# The BULLETIN OF THE BEAUX-ARTS INSTITUTE OF DESIGN

THE BULLETIN OF THE  
BEAUX-ARTS INSTITUTE OF DESIGN  
MAY 1953 VOL. XXIX NUMBER FOUR SCHOOL YEAR 1952-1953

## AN INDUSTRIAL STEEL TOWN

PERSPECTIVE - NEIGHBORHOOD CENTER

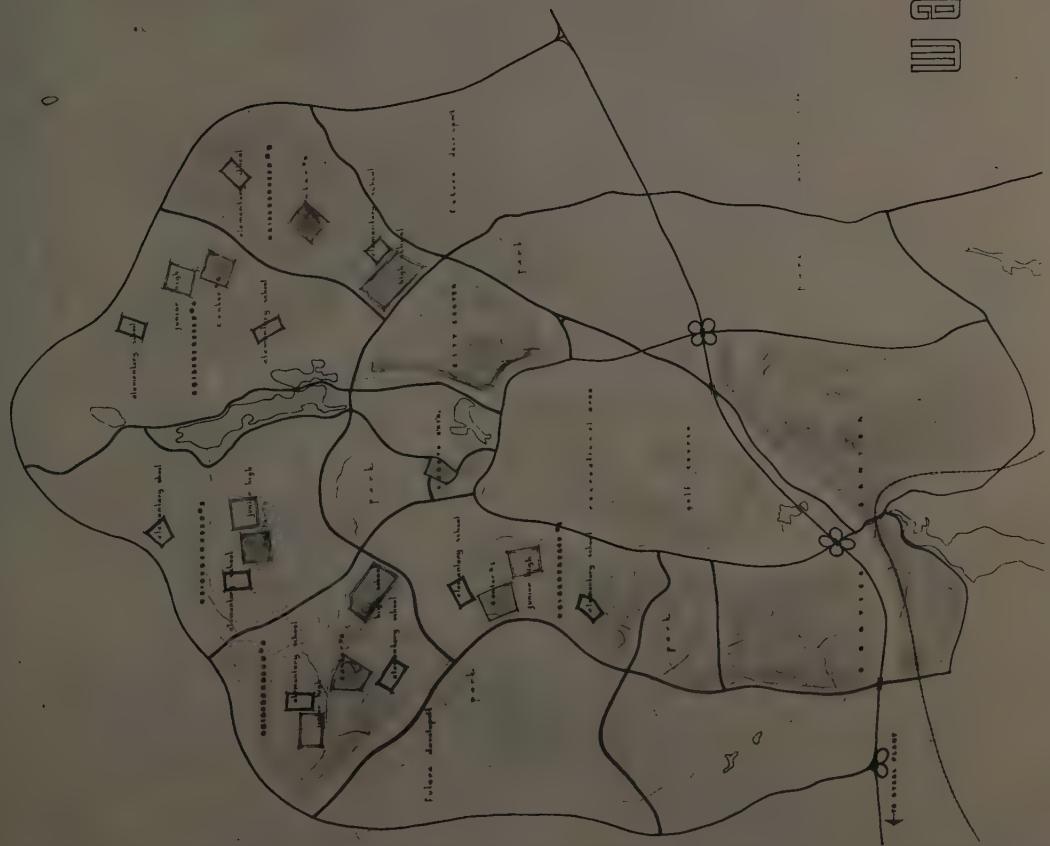
D.A.HINSHAW, UNIVERSITY OF NOTRE DAME - FIRST PRIZE: THIS PLAN INDICATES AN APPRECIATION FOR THE TOPOGRAPHY IN THE POSITION AND SHAPE OF THE NEIGHBORHOODS; THE NEIGHBORHOODS ARE INTELLIGENTLY DISPOSED ABOUT THE CIVIC CENTER; AND THE INTER-NEIGHBORHOOD CIRCULATION IS WELL DEVELOPED. THERE WAS SOME CRITICISM IN THE JURY OF THE FACT THAT THIS STUDENT DID NOT INDICATE THE MAJOR NEIGHBORHOOD CIRCULATION, I.E., THE COLLECTOR ROADS WITHIN EACH NEIGHBORHOOD AND TO THE NEIGHBORHOOD CENTER, BUT THE OVERALL GOOD QUALITIES OF THE PLAN WON THE APPROVAL OF THE JURY. THE DISPOSITION OF THE SCHOOLS, THE HOSPITAL AND OTHER ELEMENTS OF THE PLAN IS GOOD. THE VIEW FROM THE HIGHWAY WOULD BE PLEASANT AND INVITING. THE LOCATION OF THE SERVICE CENTER SOUTH OF THE HIGHWAY, THOUGH PERHAPS TOO FAR TO THE EAST, IS ACCEPTABLE.
